ISSUE: Permit to Demolish/Capsulate (partial) and Certificate of Appropriateness for alterations and addition

APPLICANT: David L. Charney

LOCATION: Old and Historic Alexandria District
414 North Union Street

BOARD ACTION: Deferred for Restudy at February 3, 2021 BAR hearing

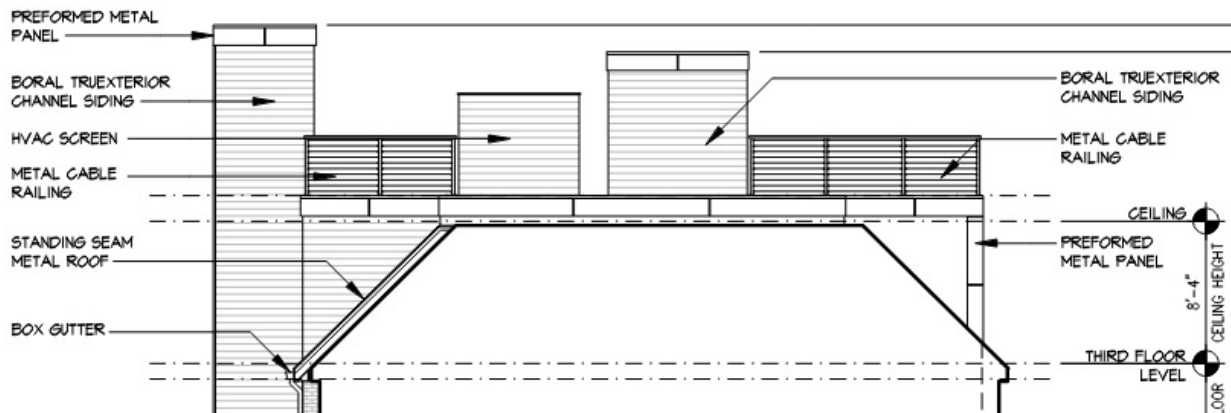
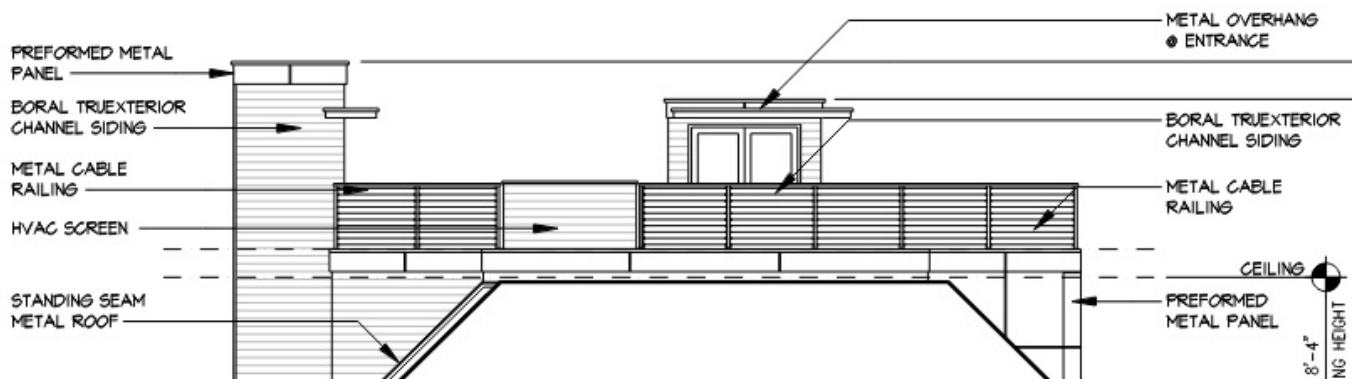
Mr. Adams felt that the third-story dormer on the primary/east elevation looks too massive and disrupts the solid/void pattern of the blockface.

Ms. Irwin noted that this dormer glass is taller and bigger than the windows below, therefore creating a heavy feel to the top of the house.

Ms. Irwin likes the casement windows and the overall direction of the design. However, she felt that the front dormer does not relate to the other windows on the house.

Ms. Sennott felt that the metal cladding of the dormer makes it look off-center and out of alignment. Ms. Irwin agreed that it looks unbalanced.

Ms. Neihardt asked if the dormer could be pushed back, made to disappear more.

Mr. Adams agreed that recessing the top could help. He liked the second-floor bay and recommended that the architect repeat that bay on the top floor to provide a level of harmony.

As indicated in Figures 6 and 7, the applicant took BAR comments into account and changed the punched windows from six lite to four lite, improving the scale in relation to the dormer and the bay window. The height of the dormer windows has been reduced by 1' and the dormer now has a higher sill. The third-floor plan on page A8 of the submission indicates that the dormer is recessed further back from the plane of the house than it was in the original design. Additionally, the window panels of the dormer are symmetrical and the same size as the window panels of the bay, as recommended by the BAR. This updated design unifies the fenestration on this elevation and breaks down the scale of the bay and the dormer. While the new elevations appear to indicate that the redesigned stair tower is more prominent than it was previously, that is not the case, as the architect has provided more detailed drawings in this submission. The grayscale lines above the railing in Figure 6 outline the previous design for the stair tower. Figure 7 shows that the new design has a much smaller footprint with additional windows to create more transparency. The architect also reduced the height of the HVAC screen to match the railing height, making it even less visible. See Figures 8 and 9 for changes to the south elevation showing the updated stair tower and the HVAC screening.

1 EAST (FRONT) ELEVATION
A9 SCALE: 1/8" = 1'-0"

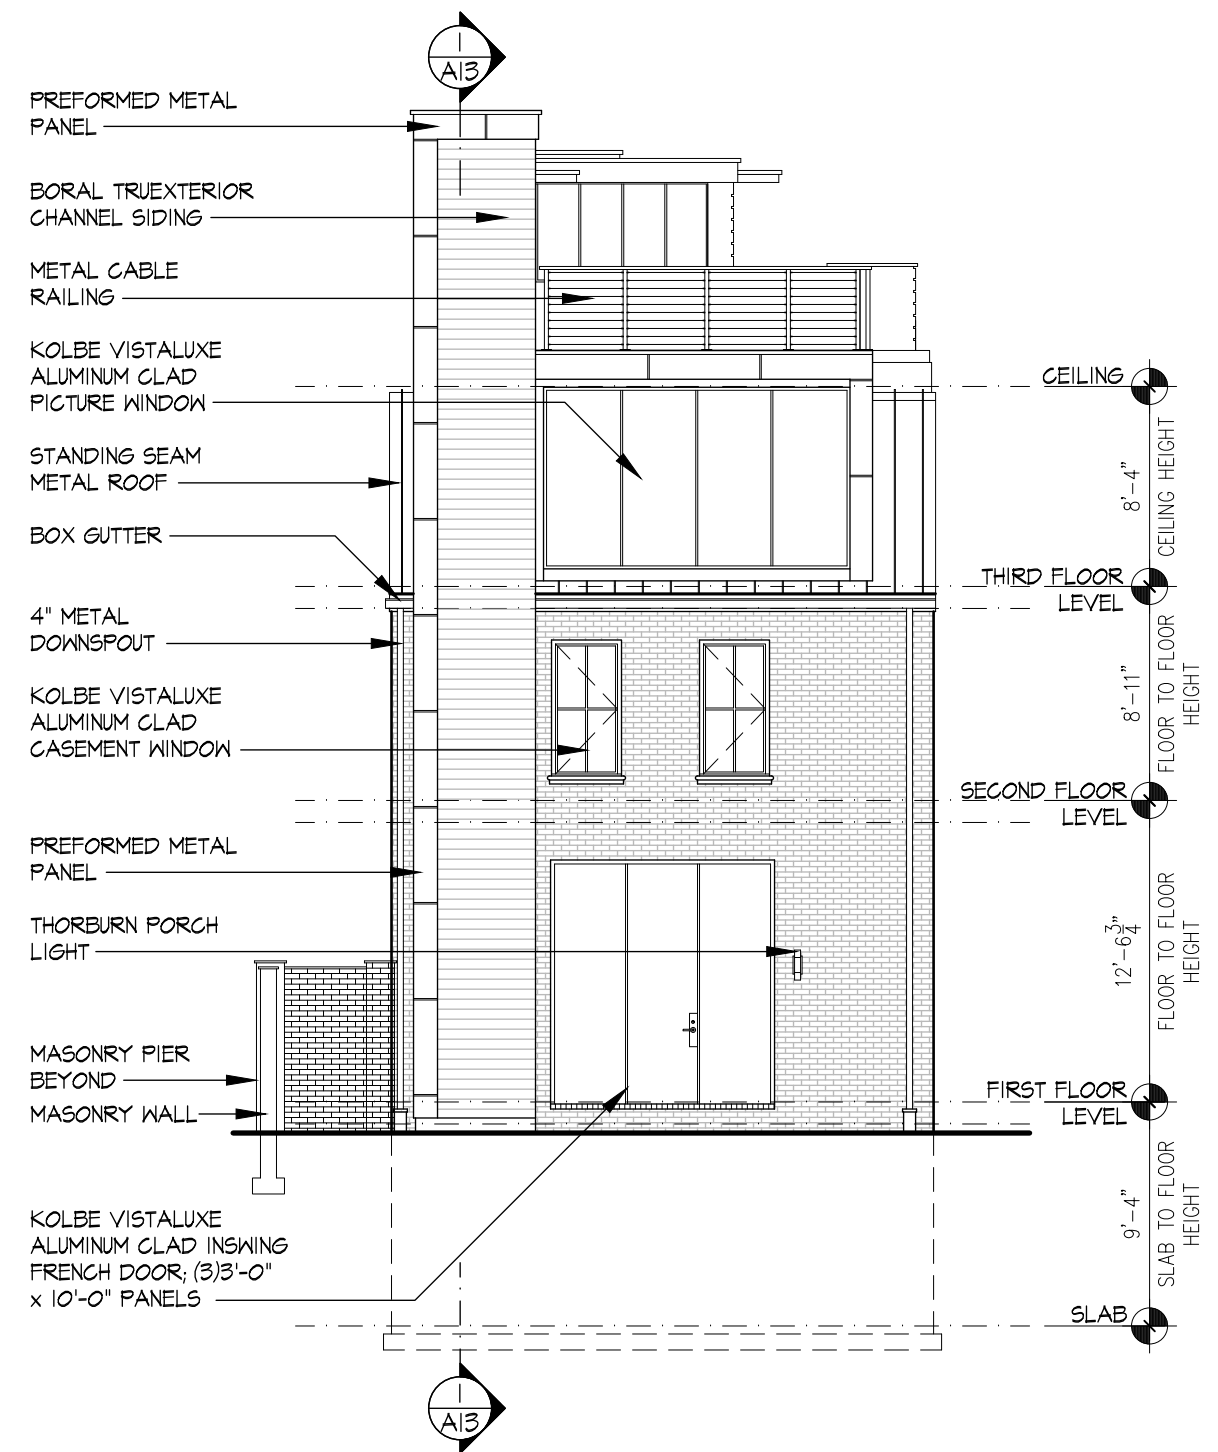
Ms. Sennott felt that the windows look narrow. Mr. Kulinski explained that they are the same size as the existing openings, but the lack of shutters makes them appear smaller.

Mr. Adams' primary concern was the size of the dormer glass; he had no issue with how the dormer relates to what is below. The design is otherwise well done.

Ms. Roberts said the design needs refinement and a better understanding as to how it fits into the neighborhood. She suggested adding divided lites to the dormer.

Ms. Irwin disagreed on the need for divided lites. She was more concerned with the alignment, feeling that if the dormer is better aligned, it may not look so heavy.

Since the February 3, 2021 hearing, the applicant has made several changes to the design based on the Board's input. Overall, the design more clearly articulates the projected construction results. It details the east/front dormer with shorter window panels, sets back the windows from the face of the building, and minimizes the size of the stair penthouse. The current design now includes better illustrations and more context as requested by the Board. Figure 6 depicts the prior design for the east/front elevation, while Figure 7 depicts the updated design with corrections in the display of color palette.
